Overview

The study, sometimes referred to as the phase 1 study, appears to use rather robust full-factorial experimental design, and draws some strong conclusions on water chemistry being the principal cause of plaster etching, while addition of calcium chloride appears to make plaster more resistant to etching. However, upon closer examination a number of deficiencies appear in the execution of the study: not all relevant variables were taken into account—leading to an unbalanced experimental design with confounded variables; the control variables were routinely out of control; once deficiencies were detected, the authors improvised on the fly and continued rather than restarting the experiment with the problems corrected so as to ensure more reliable data; and there was a clear lack of familiarity with the chemistry of water treatment, or chemistry in general. In addition, the presence of multiple uncorrected errors in the report makes it evident that the report was never peer reviewed. Given the number of deficiencies in the execution of the experiments and evaluation of the results, it is difficult to have any confidence in the data generated or the conclusions drawn. The foll

Figure 1. Plot of tank pH from Figure 5.3 in Cal Poly report. The transparent green band denotes the target pH range of 7.4 to 7.6.

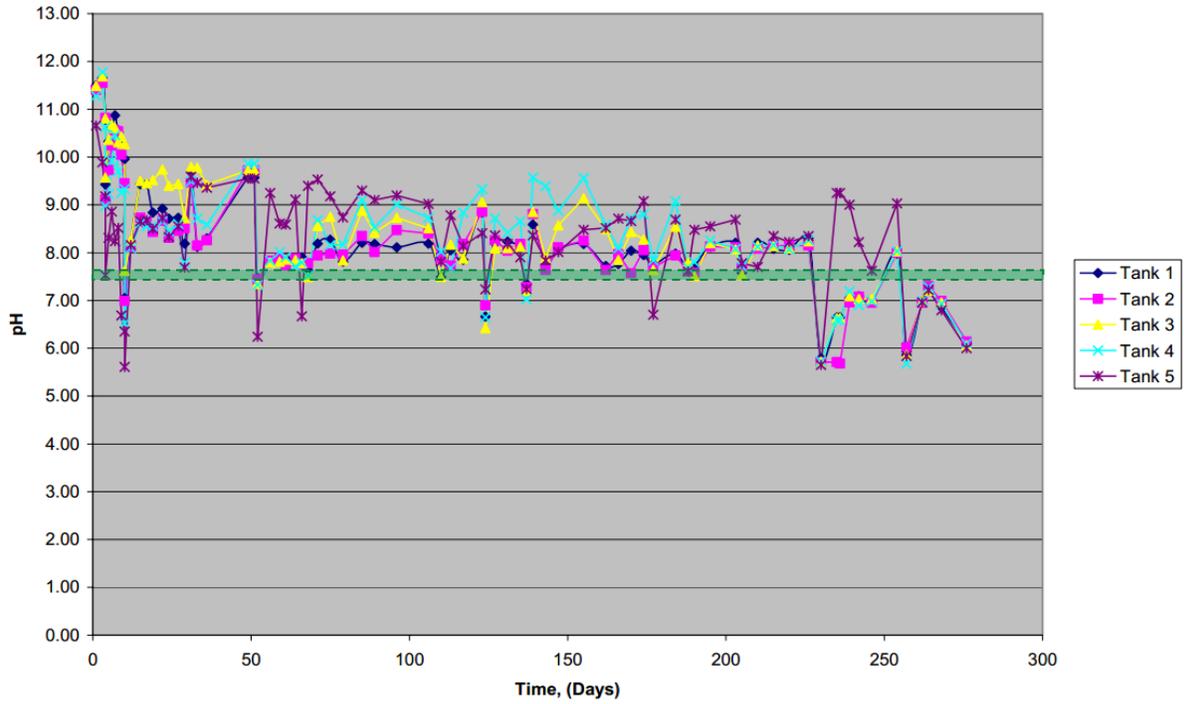
In Table 2-2 (p. 18) and on page 42 it is indicated that the objective was to maintain the pH at 7.2 to 7.4; however, as shown in Figure 1, below, the pH was typically above this range, and often below it, but rarely inside the target range in any of the tanks. Commonly the pH was more than a full unit outside the “control” range. What’s worse is that the pH in tanks 3 and 4, the “aggressive” water tanks, was typically higher than in tanks 1 and 2, which were designated as balanced. Such lack of pH control is especially problematic since pH is the most sensitive determinant of calcium carbonate saturation. (For either carbonate alkalinity or calcium hardness to have an impact equivalent to the pH being a unit outside the target range, the alkalinity or hardness would have to be outside their respective control ranges by a factor of 10!)

Figure 2. Alkalinity plot for tanks from Figure 5.6 in Cal Poly study. The intended control ranges are indicated by the red and green transparent bands.

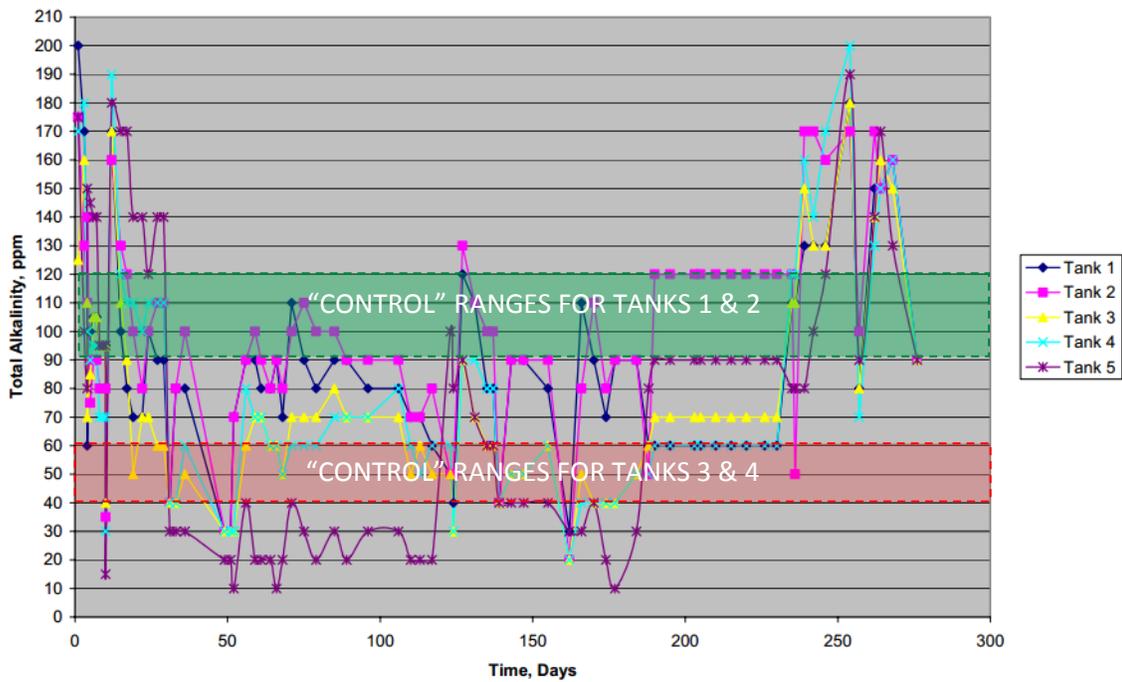
As shown in Figure 2 on the next page, total alkalinity was also out of range more often than it was in range. The alkalinity for the “aggressive” tanks, 3 & 4, was often above the control range, while for the “balanced water” tanks (1 & 2), alkalinity swung above and below the target range.

Figure 3. Calcium hardness plot for tanks in Cal Poly study. From Figure 5.7 in Cal Poly report.

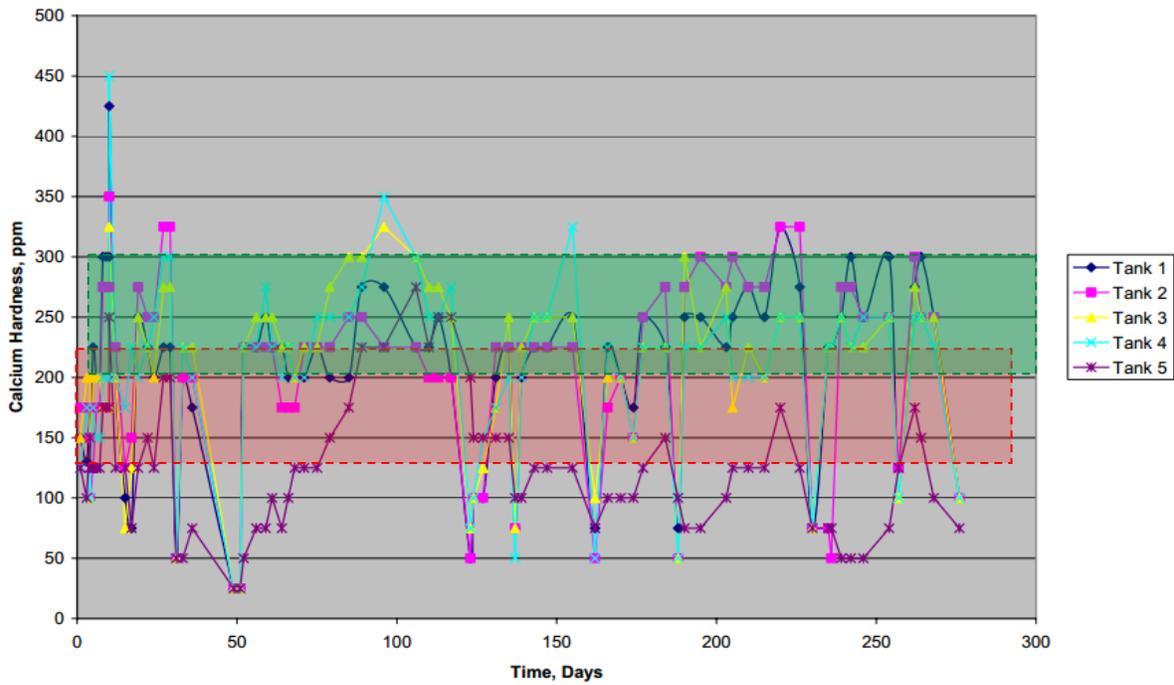
Similarly Figure 3 shows that calcium hardness was also often outside the designated control ranges for the respective tanks.

Figure 4. Free chlorine in tanks, from Figure 5.4 in Cal Poly report. The green band denotes the target range for tanks 1-4.

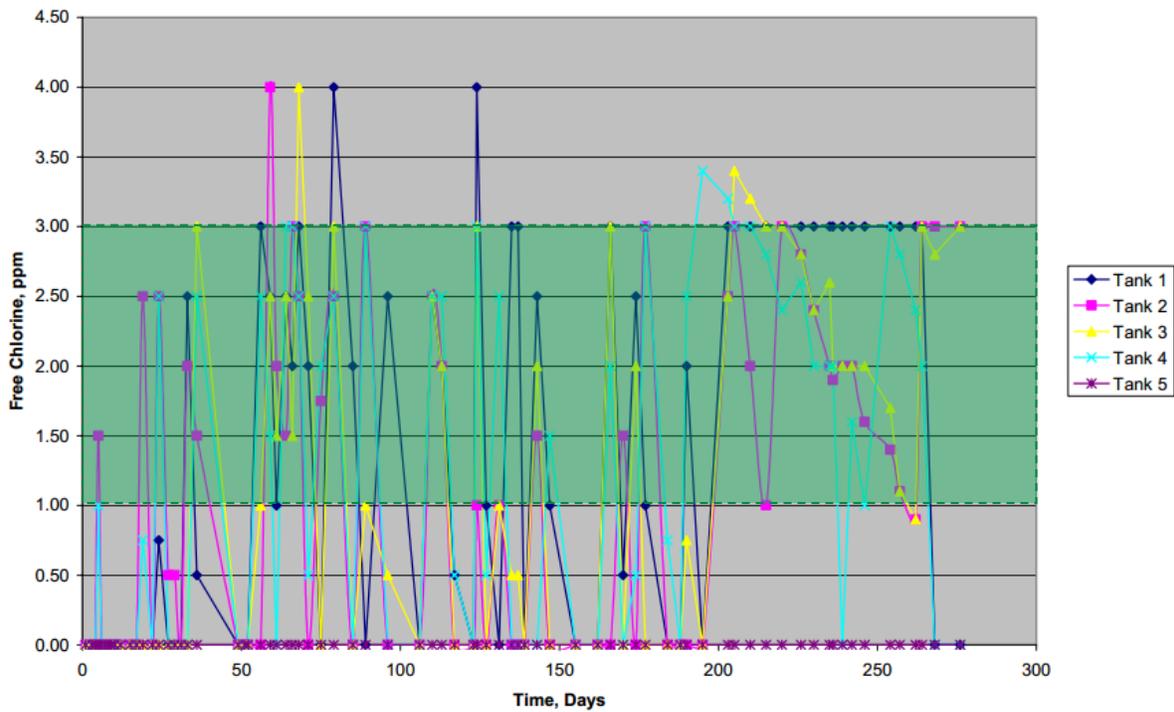
As a final out of control water chemistry influence, Figure 4 shows that while the target free chlorine range was 1 to 3 mg/L, the measured free chlorine level was often zero, introducing the possibility of biofilm gaining a foothold on the plaster, an opportunity for unplanned corrosive influences.

Figure 5. Estimated LSI for the 5 tanks used. Note that tanks 1 and 3 were treated with trichlor. This could have resulted in cyanuric acid accumulation and a resultant downshift in the LSI of 0.1 to 0.2, relative to the plots shown.

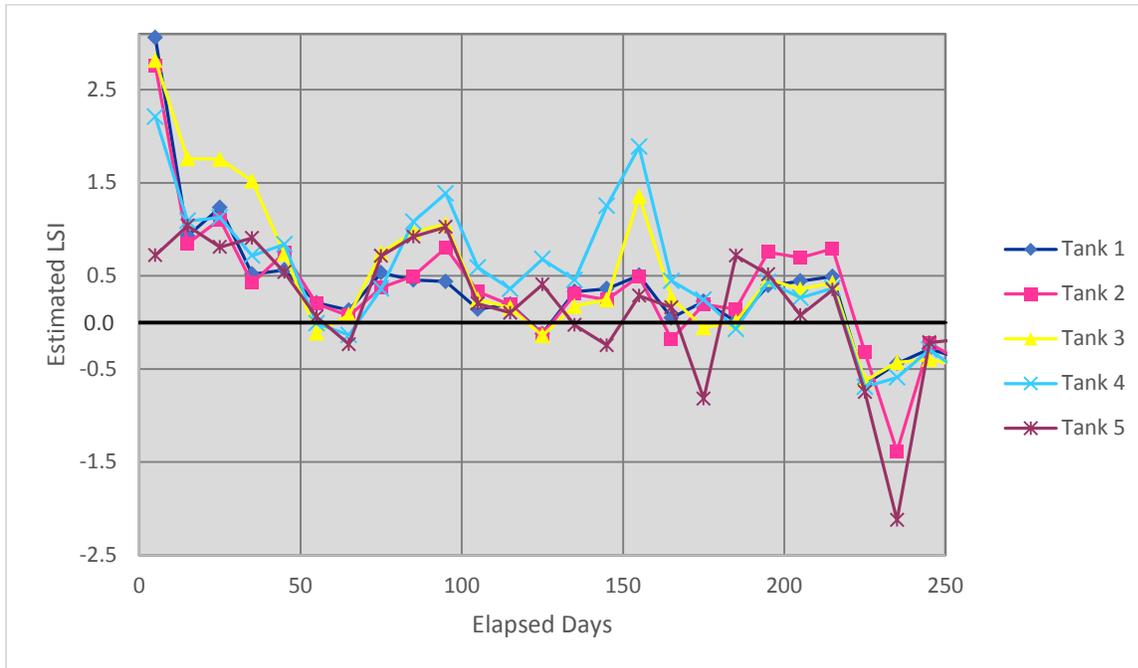
It should also be noted that no data were provided on the concentration of cyanuric acid in the tanks. Therefore, the LSI plotted does not take into account the contribution of cyanuric acid to total alkalinity, and the LSI plotted is based on the total alkalinity. Since tanks 1 and 3 were treated with trichlor (*trichloro-s-triazinetriene*), it is possible that CYA (cyanuric acid) may have sometimes accumulated to as high as a 50 ppm concentration in these tanks, depending on the frequency of water replacement relative to the rate of trichlor addition. Taking a 50 ppm CYA concentration into account would shift the affected LSI downward by ~0.1–0.2. Nevertheless, Figure 5 gives a reasonable picture of the relative LSI values for the five tanks.

- The LSI varied over a wide range in each of the tanks. In general, the tanks were rather scaling during the early weeks and aggressive in the final weeks, regardless of tank number.

- While tanks 1 & 2 were designated as "Balanced" and Tanks 3 & 4 were dubbed "Aggressive" (Table 2-2, phase 1 report), in fact all five tanks appear to be balanced in terms of the time-weighted average LSI.

- Moreover, based on the time-weighted average LSI, tanks 3 & 4 appear to have been *less*, not more, aggressive than tanks 1 & 2.
- Tank 5 appears to have been the most aggressive of the tanks, but the samples in it had the least surface deterioration.

- Tanks 3 & 4, which had the highest time-average LSI (least aggressive), were rated as giving the most severe surface deterioration.
- Plaster samples in tanks 1 and 3, which were treated with trichlor, tended to have worse surface deterioration than samples in the bleach-disinfected tanks (tanks 2 & 4). This is the sole finding that was pointed out in the phase 1 study and not contradicted by the data-based analysis provided in this critique.
